PLANNING, ZONING, & BUILDING DEPARTMENT
PZ&B Staff Memorandum: Architectural Commission (ARCOM)

SUBJECT: ARC-22-243 (ZON-23-014) 302 SEABREEZE AVE (COMBO)

MEETING: JULY 26, 2023

The applicant has submitted plans, entitled "302 Seabreeze Ave., Palm Beach, Florida" as prepared by **Smith and Moore Architects, Inc.**, dated July 10, 2023.

EXIST. REAR SITE WALL VARIANCE @ GENERATOR

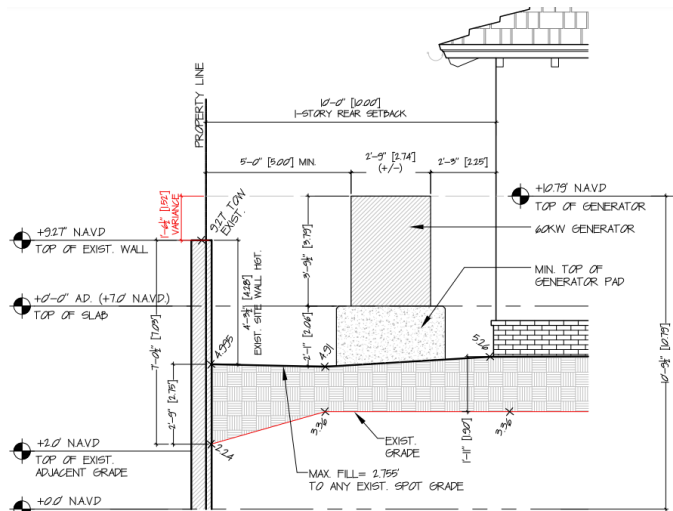
Code Section	Required	Proposed	Variance
Sec. 134-1729(1)(d)	Generator to be completely screened from neighboring property with a masonry wall	Partially screened by existing masonry wall	1' -6 ½" Unscreened

The site plan for the property locates the mechanical equipment in the east (side) and south (rear) yards. The mechanical equipment within the east yard is located either outside of the required side yard setbacks or is screened with code compliant masonry walls. The rear equipment yard adjacent to the south wall of the garage contains a 60kW generator unit within a yard setback. The generator is required to be screened from adjacent properties with a masonry wall as high as the equipment.

A masonry site wall that is proposed to remain on the rear property line measures 7'-0 1/2" in height when measured from the neighboring grade, already exceeding the 7' maximum wall height allowed by Code. As mechanical equipment is required to be placed at 7' NAVD, the generator exceeds the height of the existing wall. Sheet SP-3 of the architectural plans provides a variance diagram depicting the request.
